Re: Modification of consent request - DA2018/1 – Condobolin Wheat Siding – Lot 1 DP: 819480

Annexure 1 – Modification of Consent application

Comparison of current Consent and proposed Modification

Description of Modification

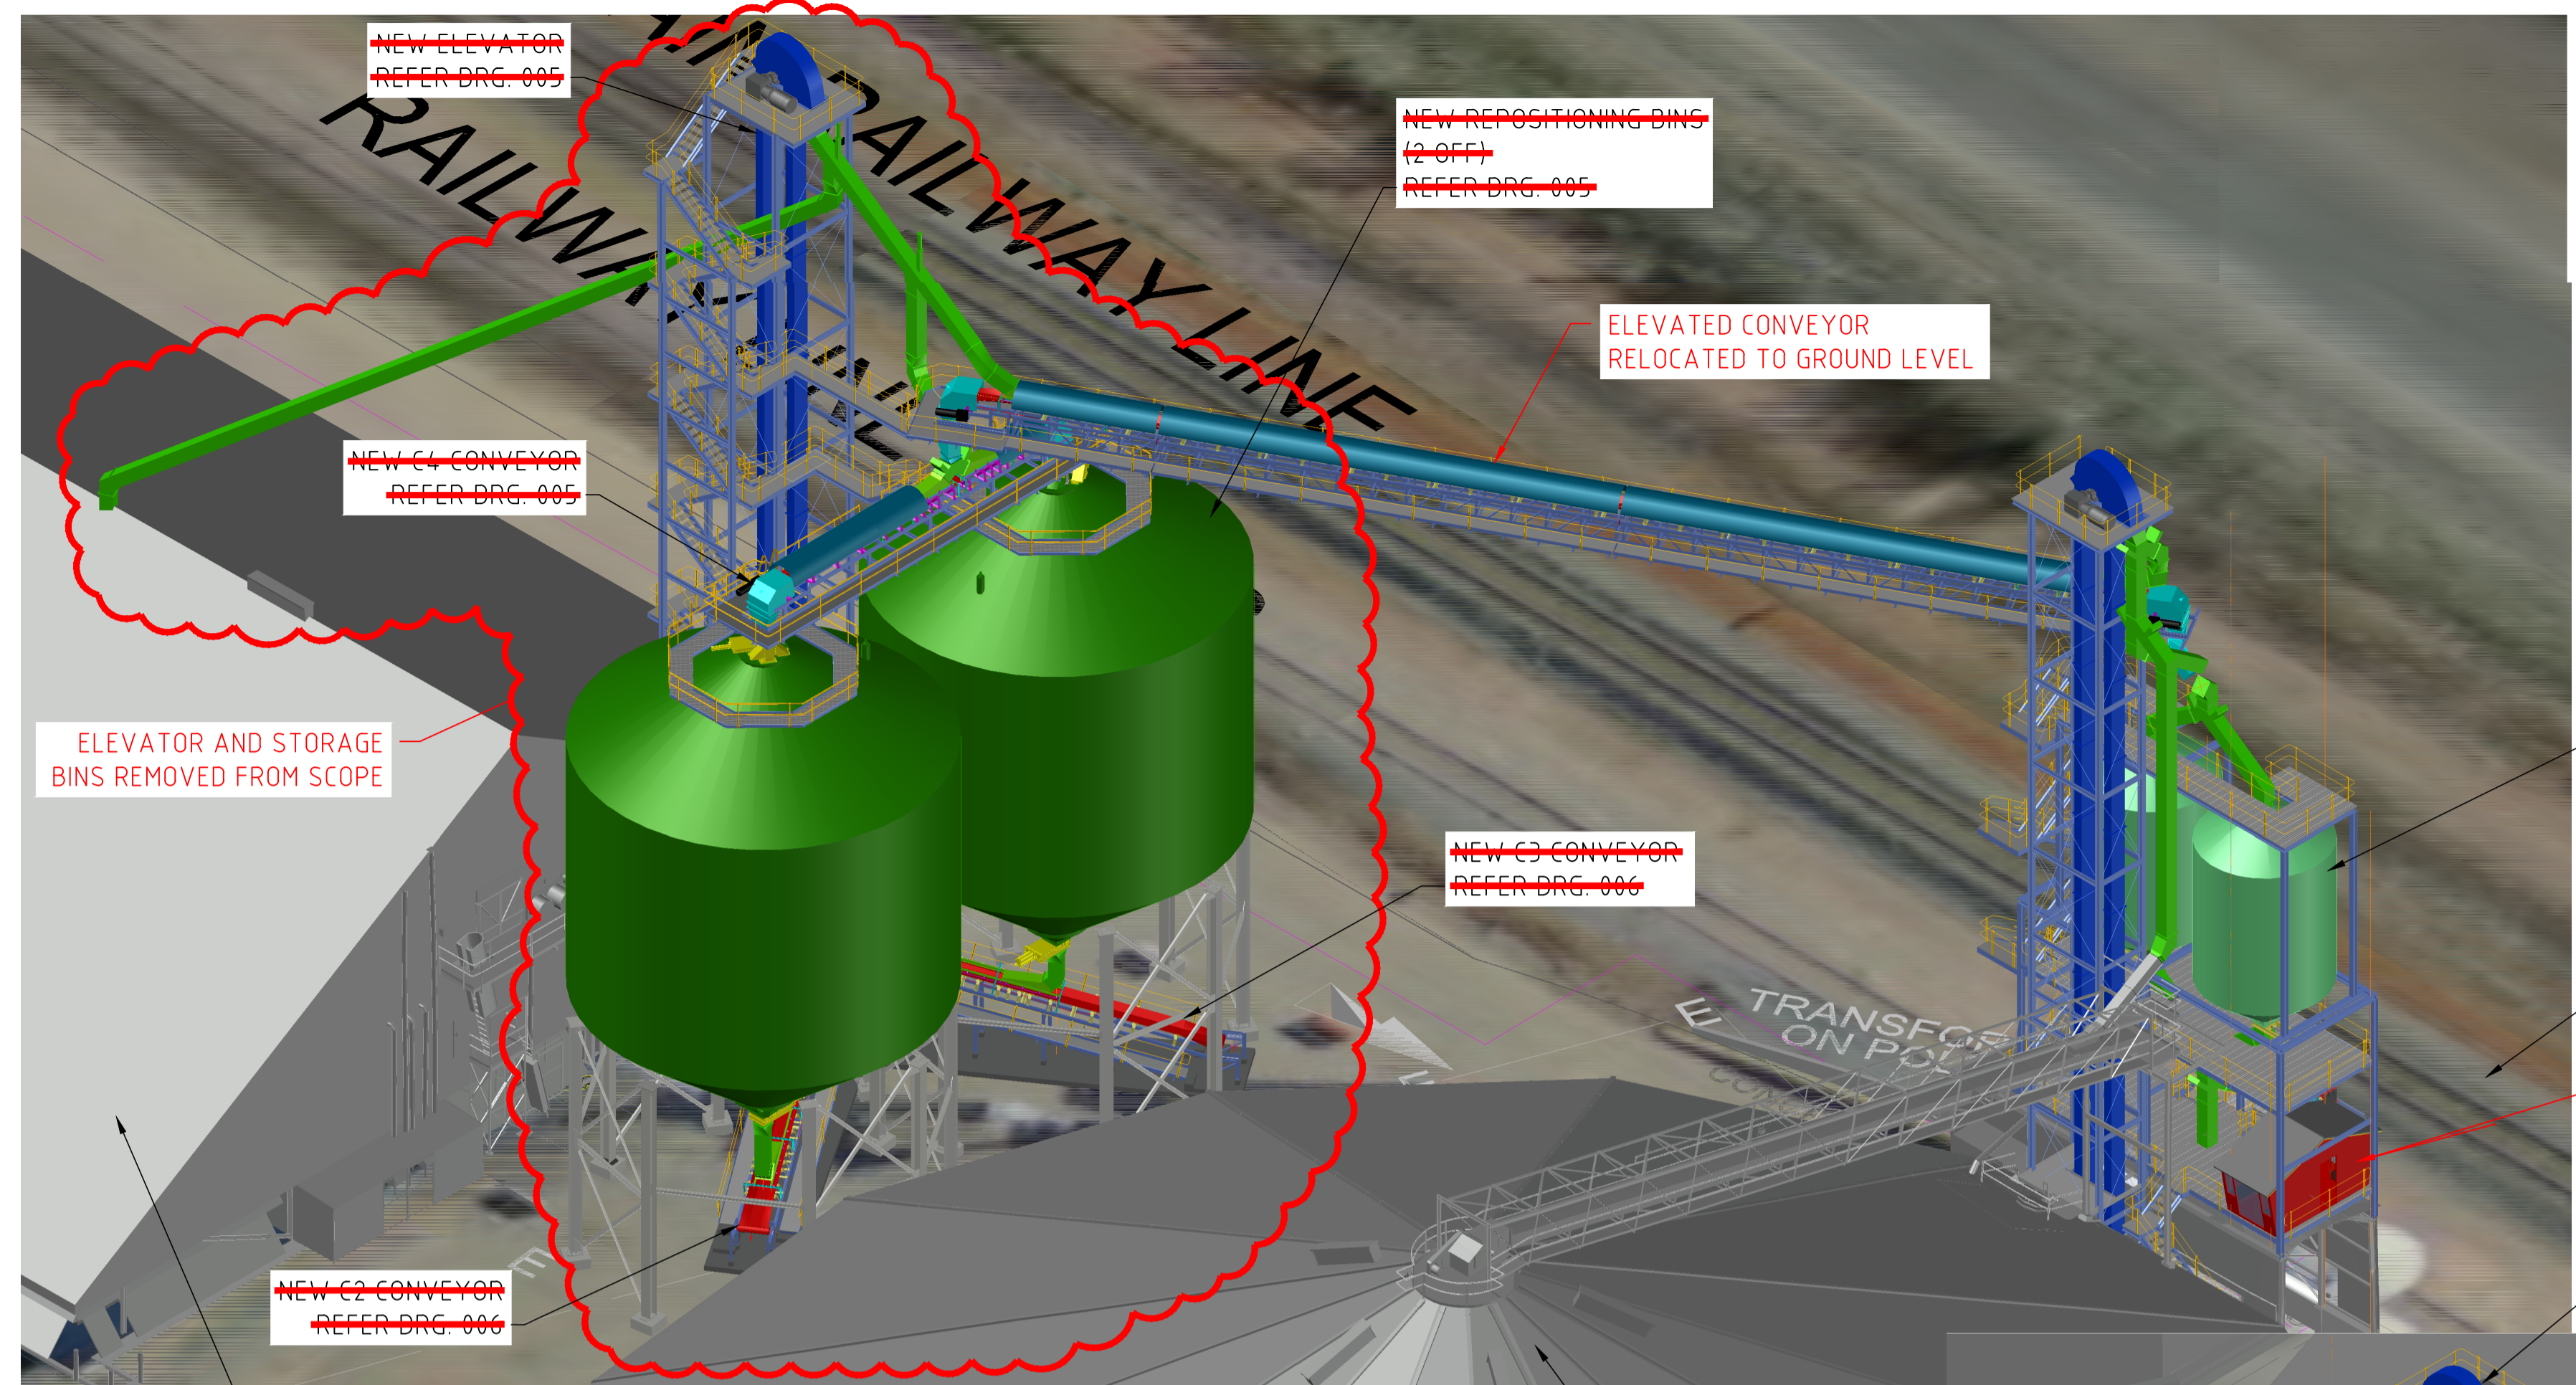
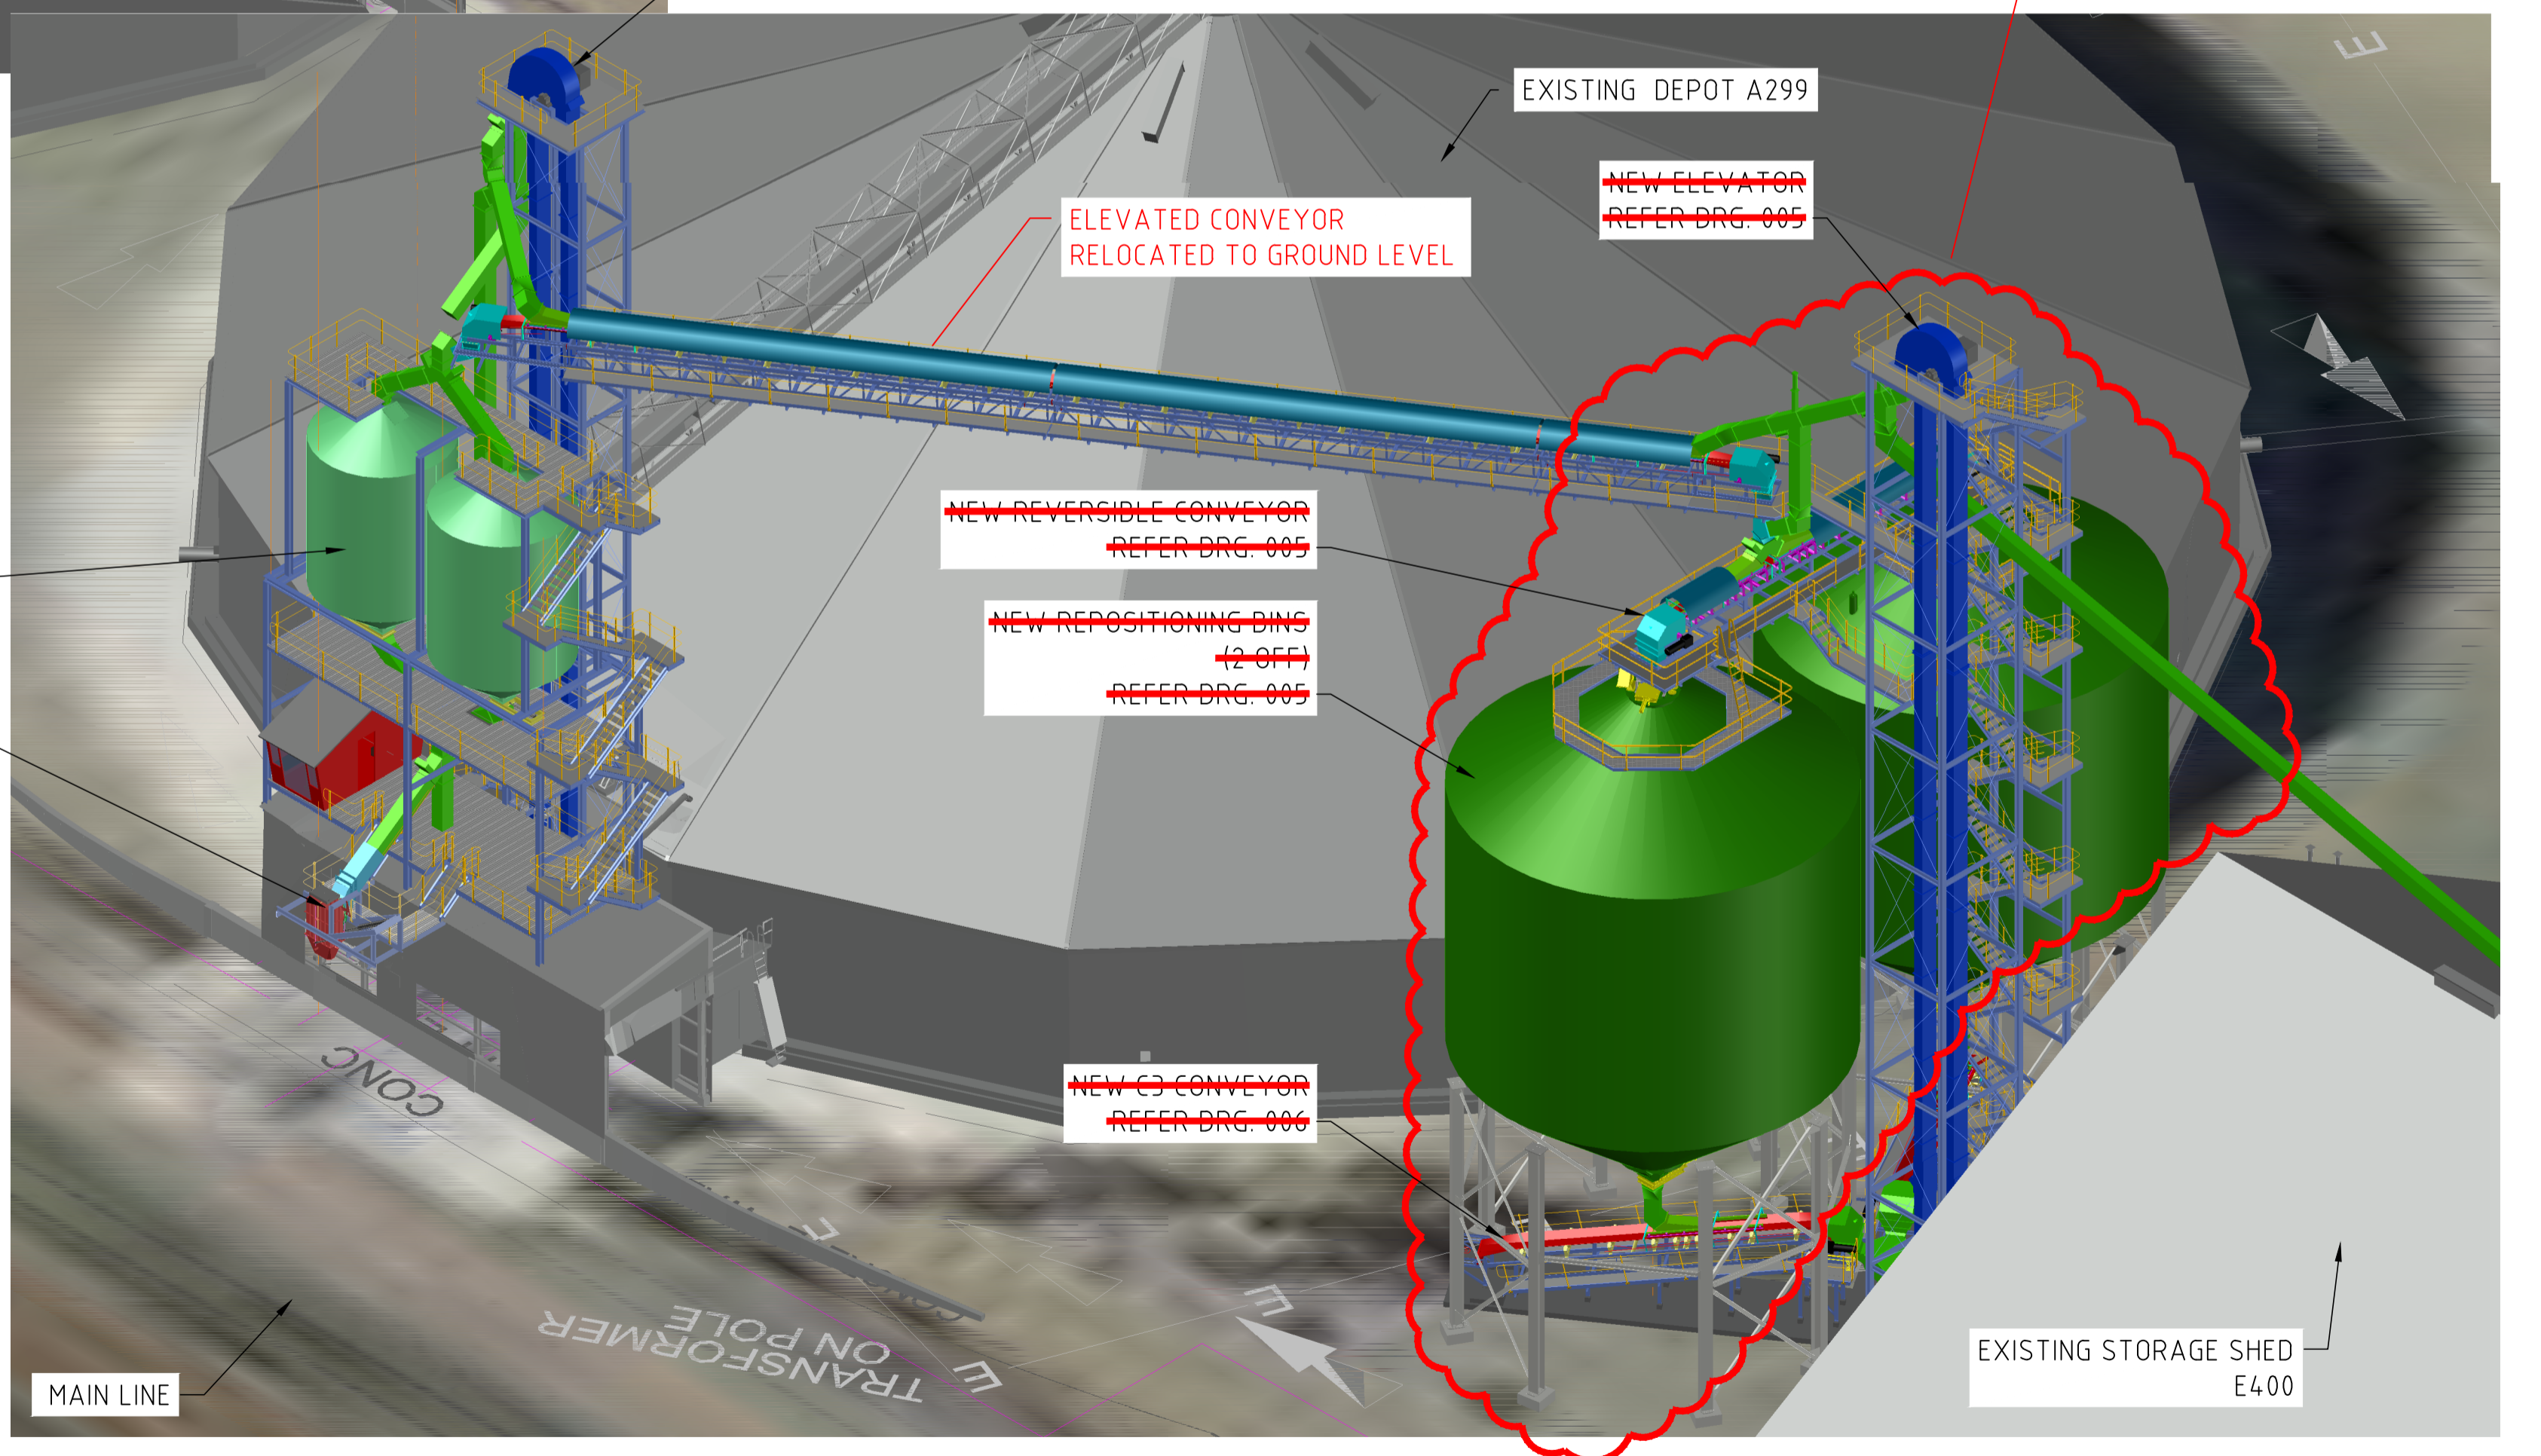
100T DUAL GARNER BIN AND RAIL LOADOUT TO REPLACE EXISTING SINGLE OVER RAIL GARNER BIN REFER DRG. 008 & 009

CONTROL ROOM LOCATION AND DESIGN REVISED

REPLACE EXISTING ELEVATOR AND SUPPORTING STEELWORK REFER DRG. 008

ELEVATOR AND STORAGE BINS REMOVED FROM SCOPE

100T DUAL GARNER BIN AND RAIL LOADOUT TO REPLACE EXISTING SINGLE OVER RAIL GARNER BIN REFER DRG. 008 & 009

Figure 2 Proposed Project layout – showing the new elevator and two grain silos that were part of the approved DA plans

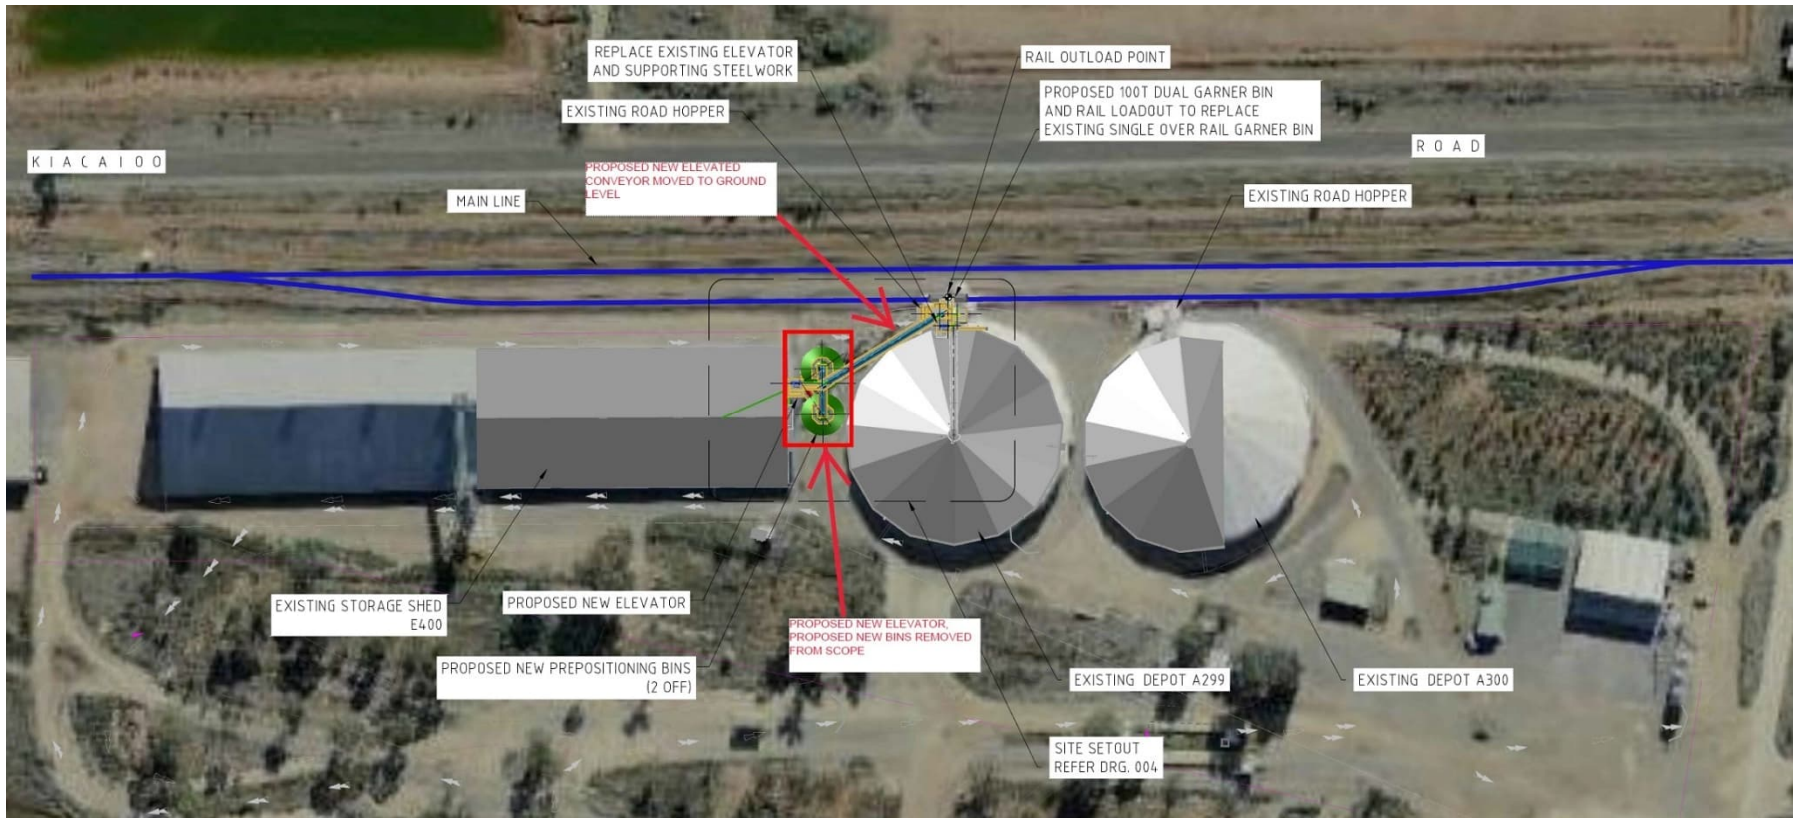
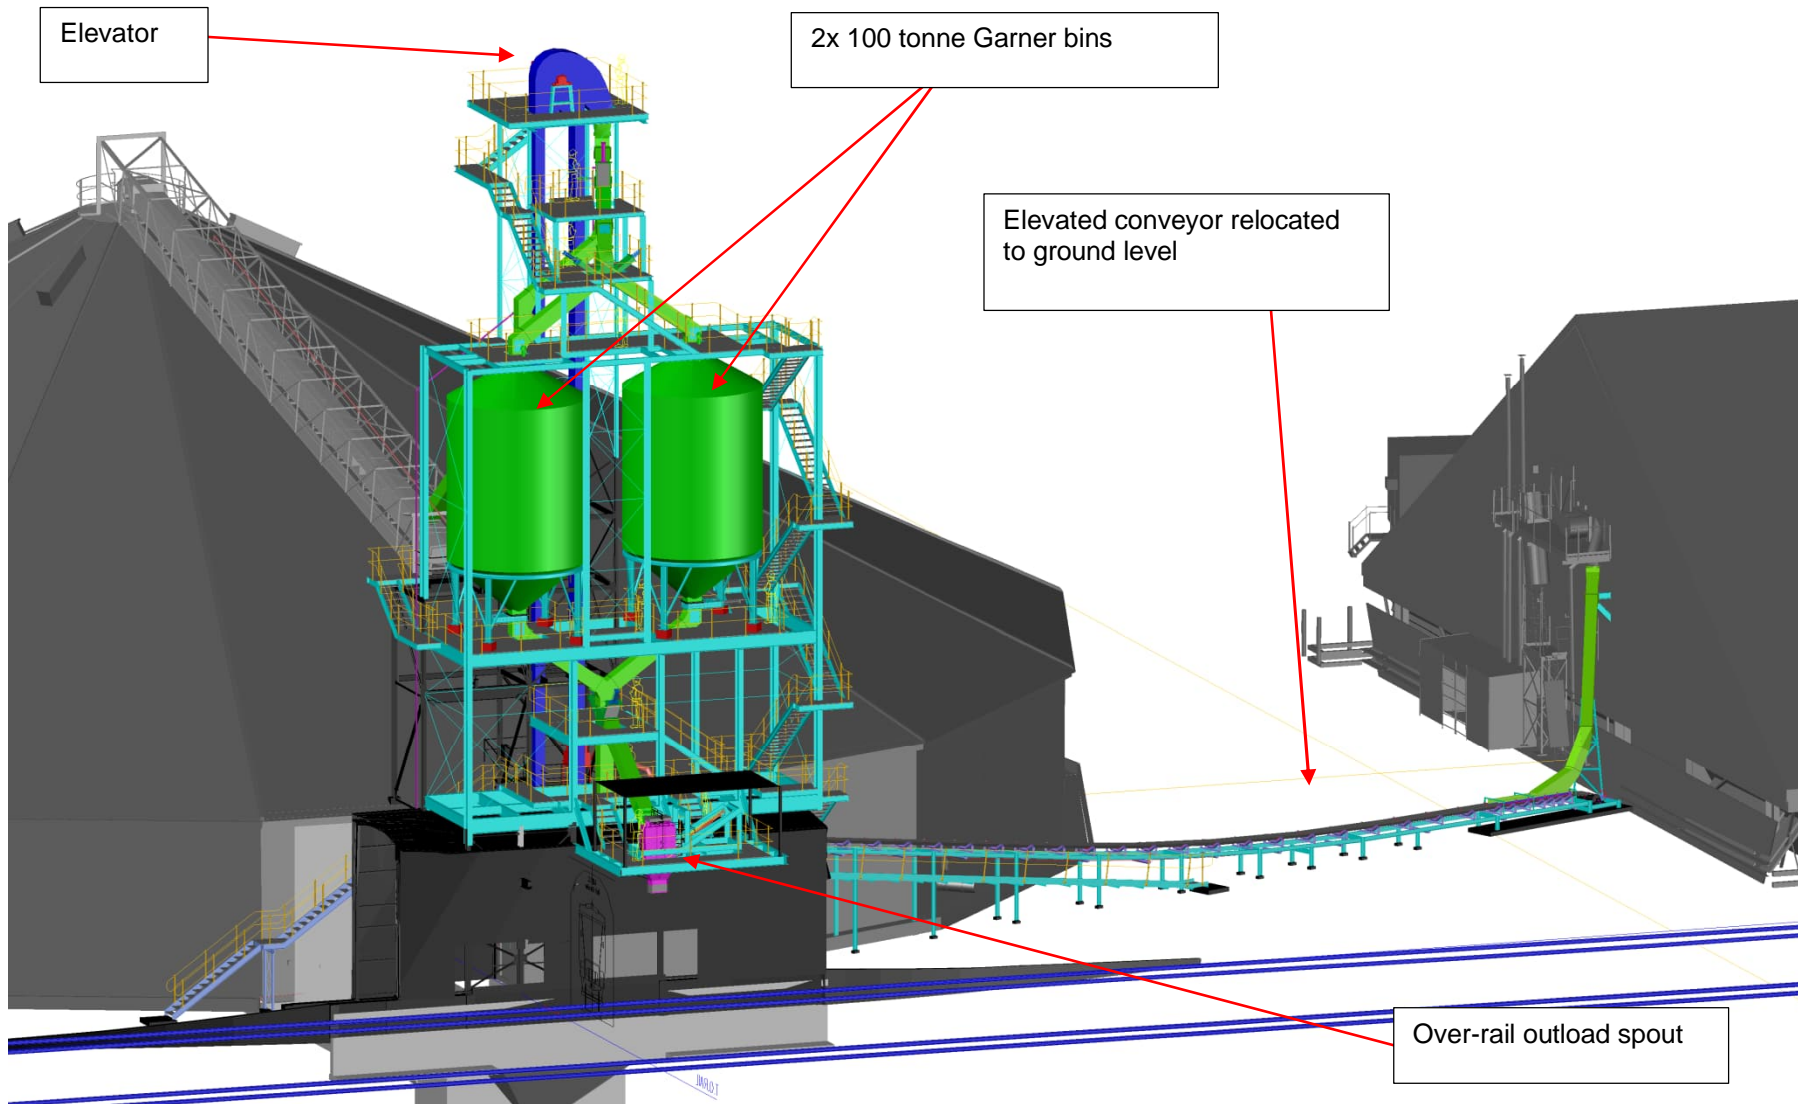
The modifications to the originally approved DA are as follows:

- The two new 1500 tonne grain silos have been removed from the plans.
- The new elevator servicing the grain silos from the storage shed has been removed from the plans.
- The new elevated conveyor has been changed to a ground level conveyor.
